CITY OF ALBUQUERQUE

**RE: Marble Brewery (Montgomery)
Grading and Drainage Exhibit
Engineer's Stamp Date 3-21-16 (File: G21D043)**

PARTIAL RE-GRADE & REPAVE PLAN
FOR DEVELOPMENT OF
9904 MONTGOMERY BLVD. N.E.
ALBUQUERQUE, NEW MEXICO
MARCH, 2016

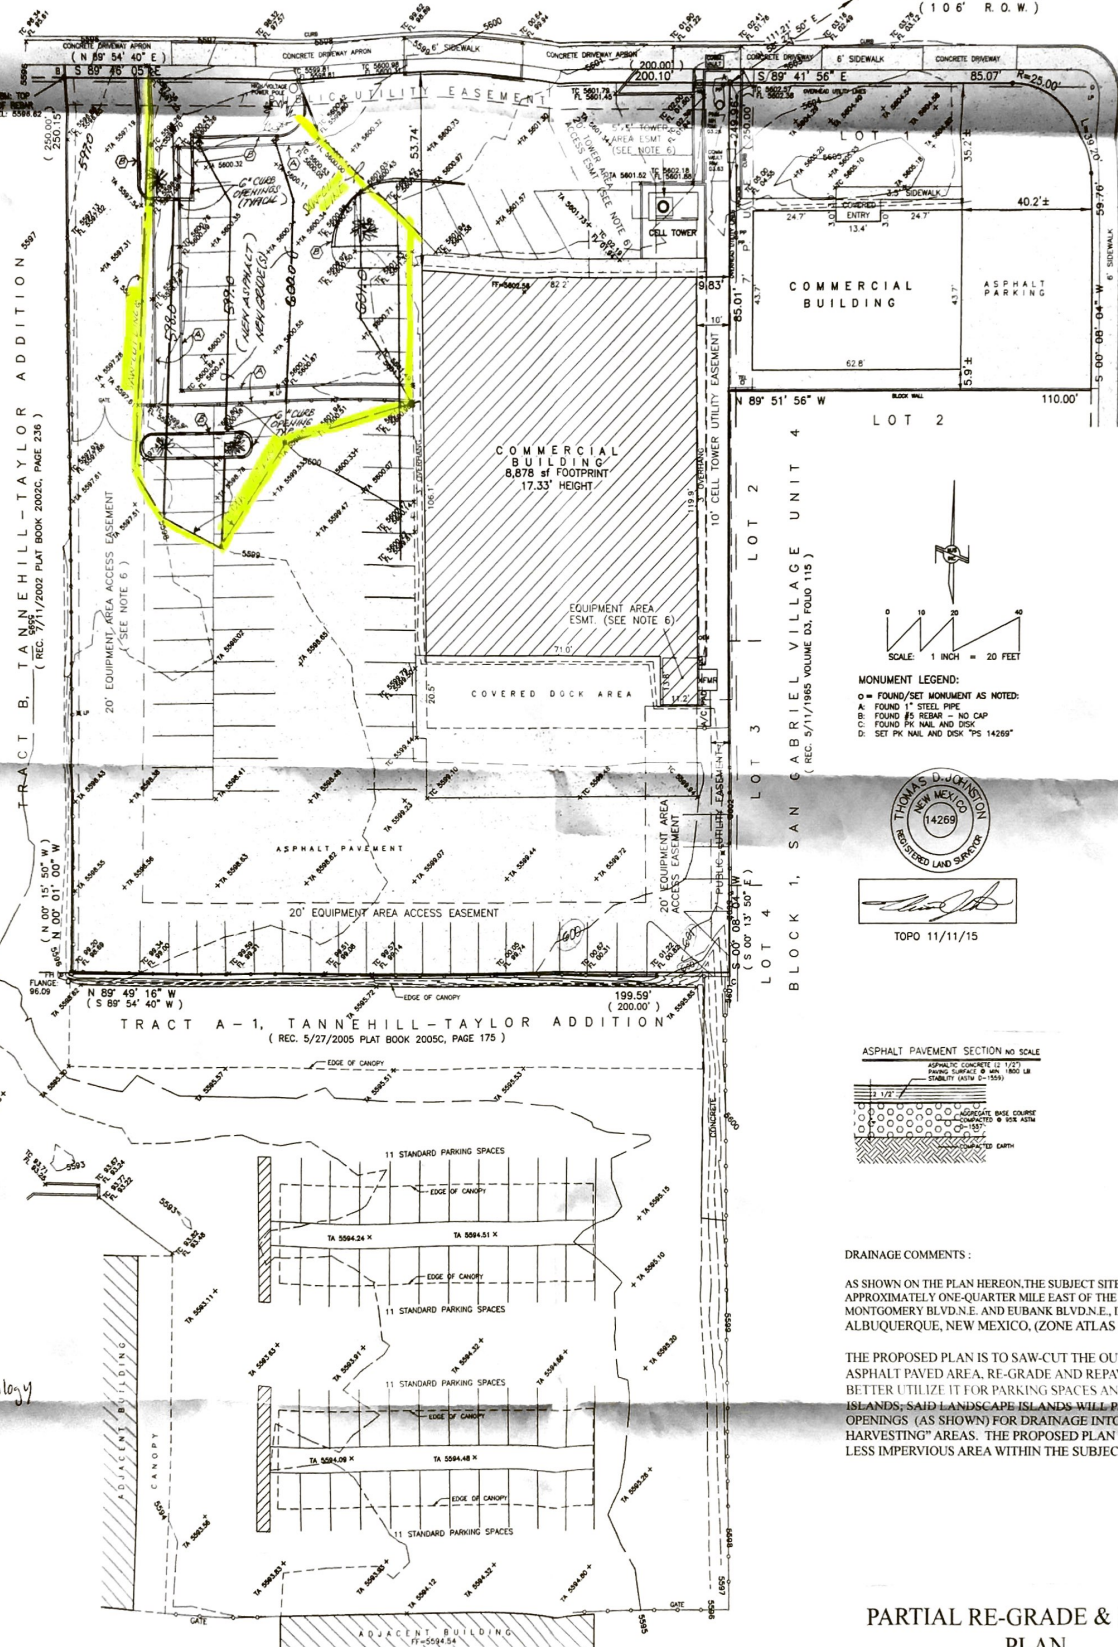
Based upon the information provided in your submittal received 3-22-2016, the above referenced Grading and Drainage Plan is approved for Building Permit.

Please attach a copy of this approved plan in the construction sets when submitting for the building permit. Prior to Certificate of Occupancy release, Engineer Certification per the DPM checklist will be required for Transportation; during that review, the grading improvements will be inspected. A Hydrology Certification will not be required given the small scale of the paving improvements.

George will email the A in pavement to do the hydrology

Existing pavement SF = 1635 SF
Proposed pavement = 1520 SF (Pavement removed is replaced w/ landscaping)
D115

Decrease of 115 SF of impervious area
First flush to be captured in new landscape islands
